Re: 09-AFC-7 Palen Solar Power Project

**Re: Comments on the Preliminary Determination of Compliance for the Solar Millennium Palen Solar Power Project (No. 163054)**

*Re: Review of Preliminary Determination of Compliance for Palen Solar Electric Power Project  
(Application No. 502597)*

**Figure 1: Therminol VP-1 Temperature vs. Vapor Pressure**  
(data from Solutia Technical Bulletin 7239115B, 1999)

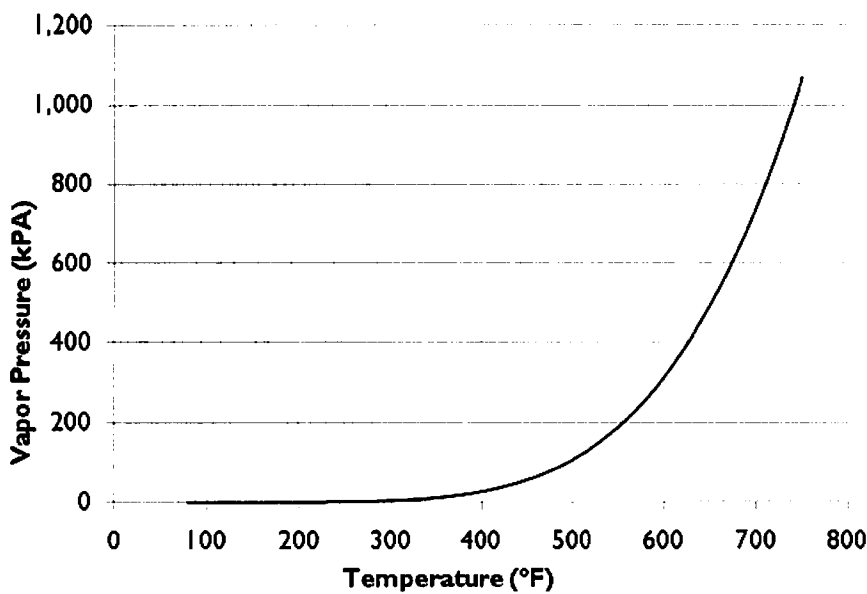
However, the HTF daily operating range cycles between approximately 430°F and 740°F every day;<sup>7</sup> during normal operation, HTF enters the solar field at 565°F and leaves the field at 739°F.<sup>8</sup> Thus, for most of the day and during normal operation, the operating temperature is above the normal boiling point of the HTF of 495°F.<sup>9</sup> The vapor pressure at these operating temperatures rises drastically and ranges from about 40 kilopascals ("kPA") at 430°F to about 220 kPA at 565°F and 900 kPA at 740°F, as shown in Figure 1.<sup>10</sup>

Thus, because the HTF piping system does not operate under atmospheric conditions (68°F and 1 bar), the SOCFI emission factors for "Heavy Liquid" are not appropriate for calculating fugitive VOC emissions from the Project's solar fields. Rather, the emission estimates should be based on emission factors for "Light Liquid" and "Gas". (Of course, it would be far preferable to conduct field measurements at existing solar trough plants, *e.g.*, the SEGS plants at Kramer Junction, CA, rather than relying on average SOCFI emission factors conducted at industries with entirely different operating conditions.)
